Commission of Architectural Review

7. COA-167481-2025	Final Review	Meeting Date: 6/24/2025
Applicant/Petitioner	Dawn Hollander	
Project Description	Repaint house and trim, add black shutters and wrought iron porch rails, replace deteriorated front door	
Project Location		
Address: 730 North 23rd Street		
Historic District: Union Hill		
<p>High-Level Details:</p> <p>This application is the result of a Notice of Violation issued to the property in May 2025 for the completion of exterior work with out a Certificate of Appropriateness.</p> <p>The applicant asks for retroactive approval of several exterior alterations to a two story, masonry, Italianate building circa 1890.</p> <p>Exterior alterations include:</p> <ol style="list-style-type: none"> 1. Replacement of a non-original front door 2. Installation of new front porch railings 3. Installation of shutters 4. Wrapping of extant iron porch posts with tapered square column sleeve 5. Painting building white with black trim

Figure 6. 730 N. 23rd Street. 1950s. Original front porch turned posts and railings are present.

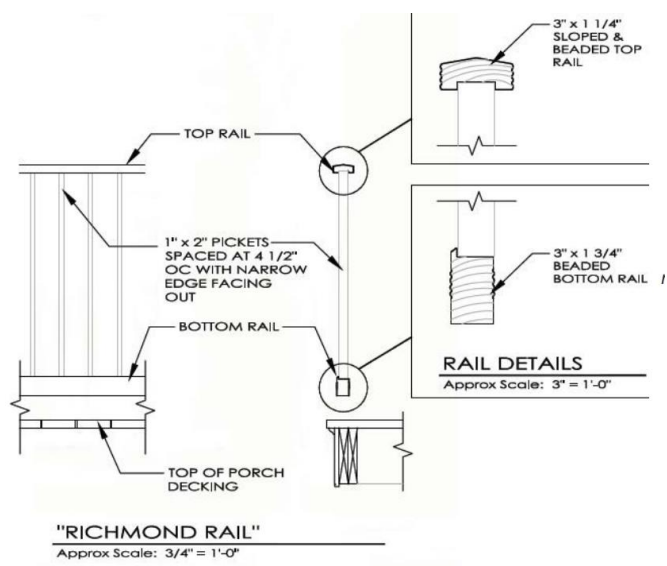
<p><u>installed on the property.</u></p> <p><u>Staff recommends that a new porch posts that match either the historic 1950s (figure 6) photograph or the previous porch be installed, or another design discussed with the Commission.</u></p> <p><u>Staff recommends that the new handrails on the porch be constructed of a more traditional material like wooden Richmond Rail (see Figure 7).</u></p>
Building Elements, Porches & Entrances and Doors, pg. 71	<p><i>14. Do not remove original doors and door surrounds. Replacement doors and door surrounds with stamped or molded faux paneling or leaded, beveled, or etched glass are strongly discouraged and rarely permitted. Stamped or molded faux paneled doors are inappropriate substitutes for door types found in historic districts.</i></p>	<p>The applicant is proposing to remove a non-original paneled front door which features a fan light.</p> <p>The proposed door is a Beechwood Therma Tru Door (Fiber Glass) with a transom and two vertical inset panels.</p> <p>Because the original door to the building has been removed and the existing door isn't the original, the replacement of the extant door will not cause any loss of historic material or character defining features of the building.</p> <p><u>Staff recommends approval of the replacement of the extant door.</u></p>
